Staff Report to the Zoning Administrator

Application Number: 251501

Applicant: Matson Britton Architects
Owner: Sandy and Kevin Huber
APN: 043-152-54
Site Address: 625 Beach Drive, Aptos

Project Description: Proposal to convert a 2,568 square foot single-family dwelling into an accessory dwelling unit (ADU) and to construct a new, 2,909 square foot primary dwelling on a vacant portion of the parcel. The proposed dwelling would be constructed over a 2,130 square foot non-habitable understory with a 271 square foot garage and 294 square foot storage area.

SITE PLAN

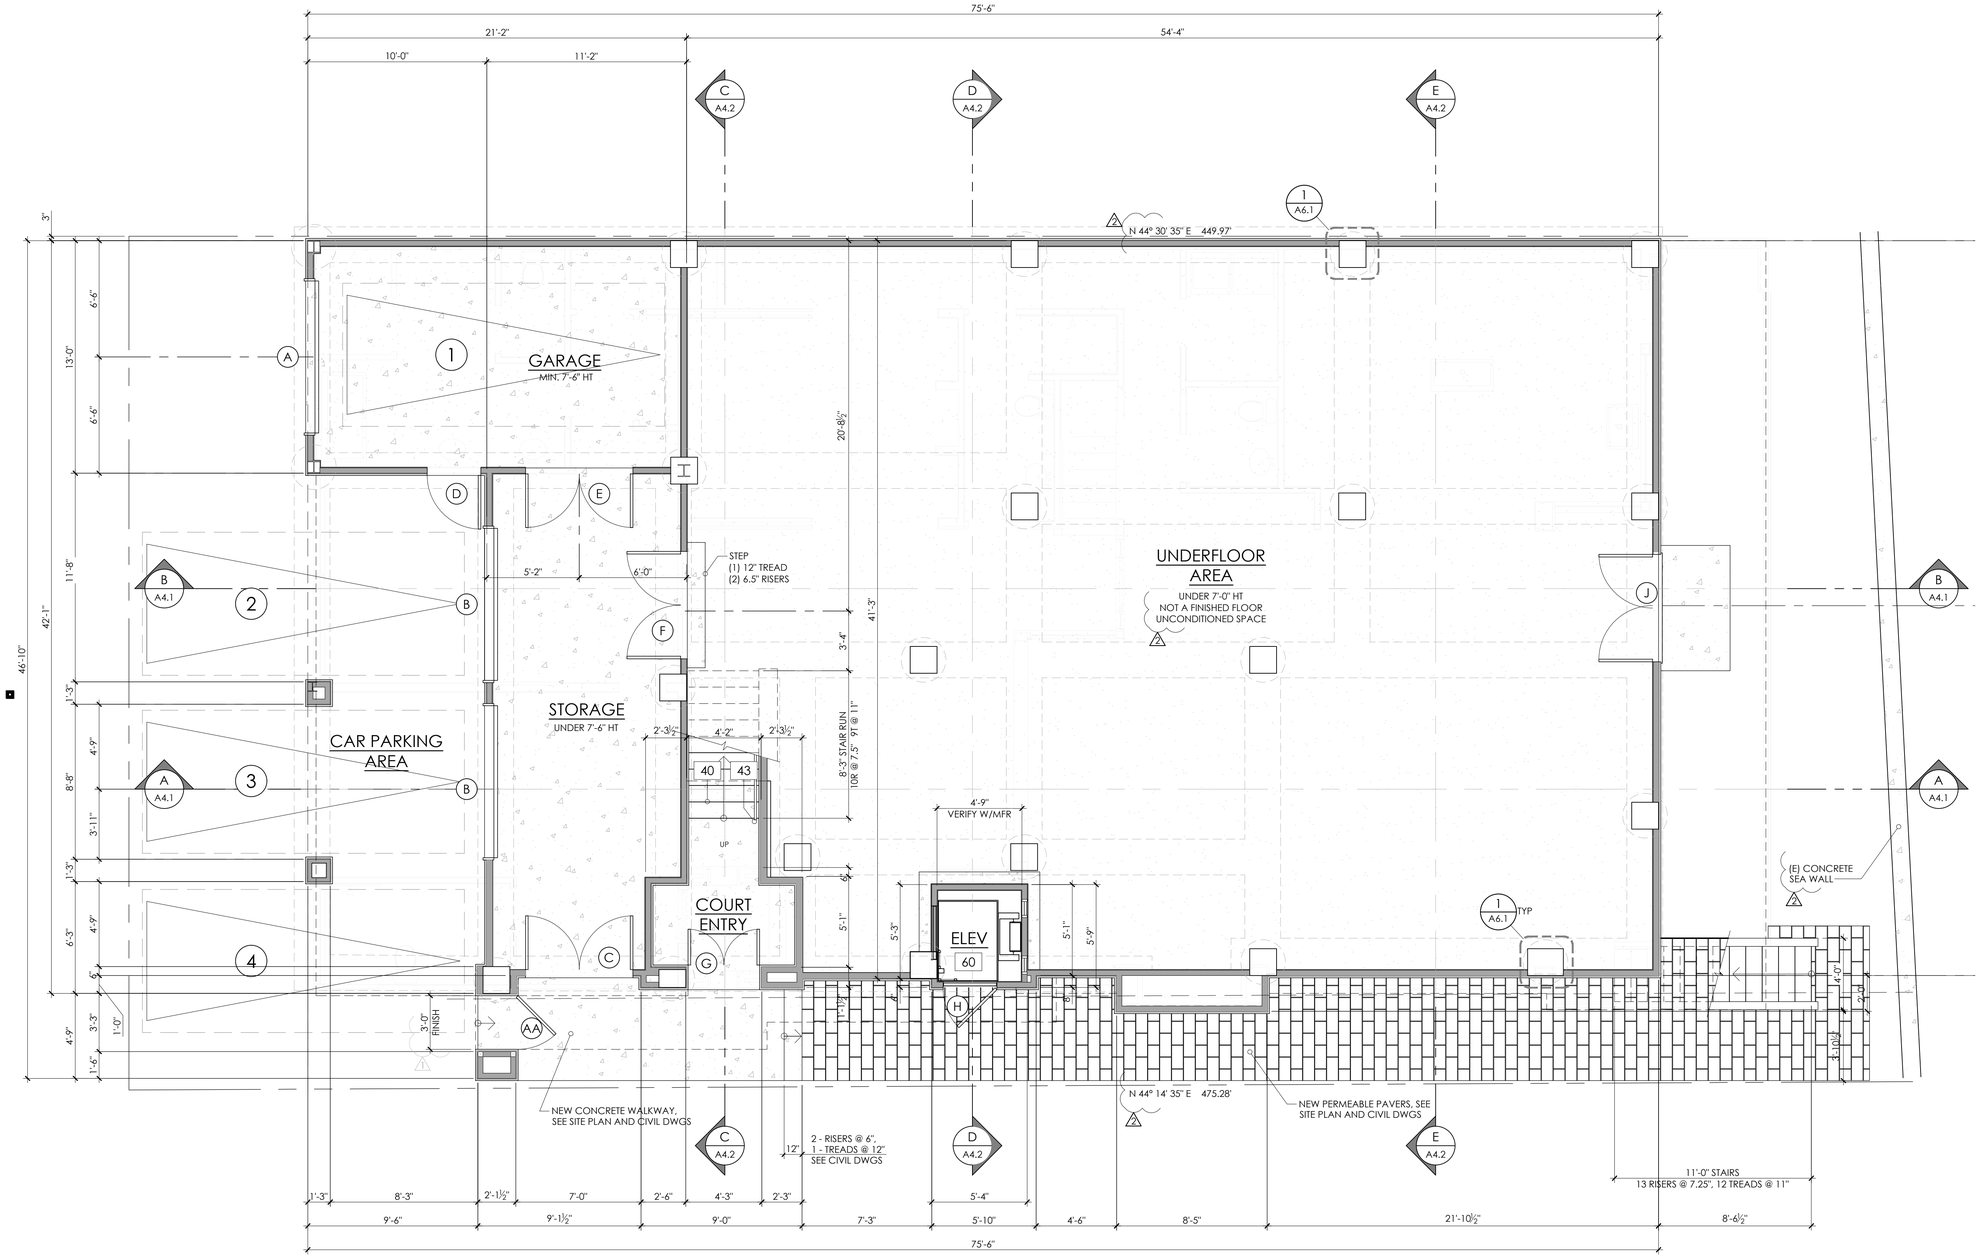
1. Sheet A1.0 shows the private sewer lateral connecting to a water main and water service line connecting to a public sewer main. Sheet C-1 shows a more accurate alignment.

SOUTHEAST ELEVATION

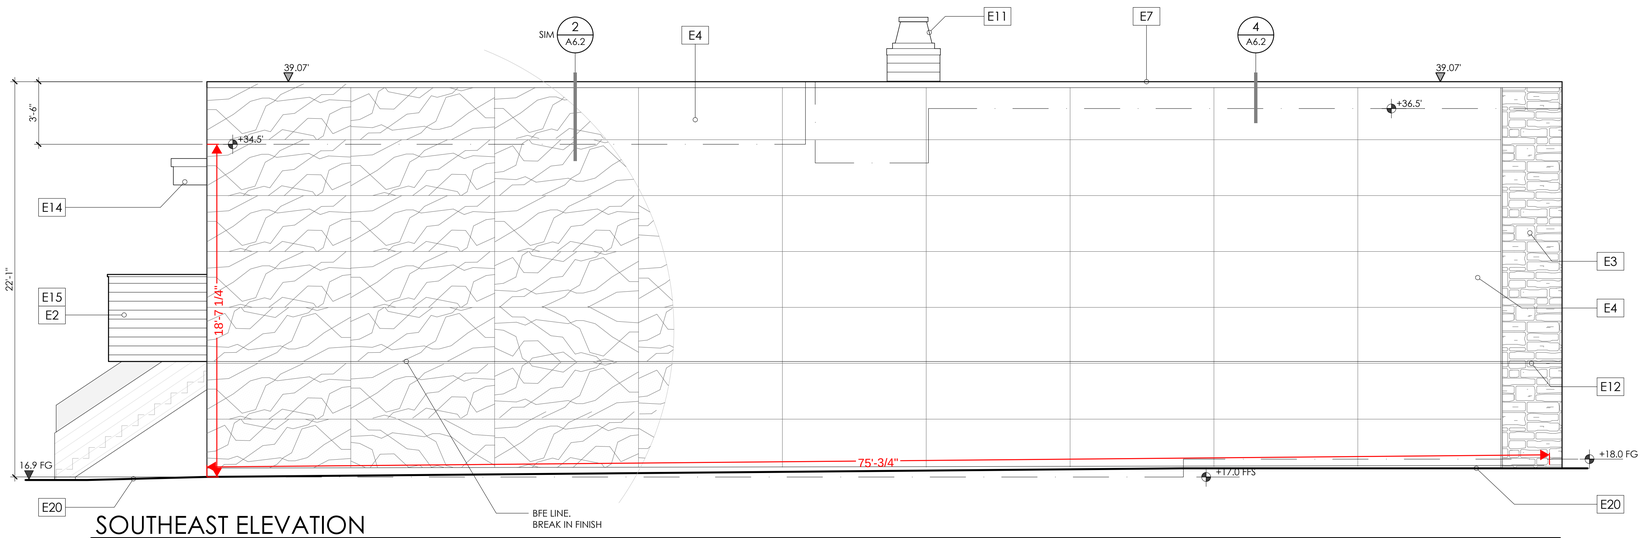
The southeast elevation does not achieve the same level of compliance as the remainder of the structure. The wall plane at this elevation extends from the property line vertically 22 feet from grade and spans nearly the entire width of the building area, 75-feet in total. The wall does not include wall plane variation, roofline variation, building modulation, or façade articulation that
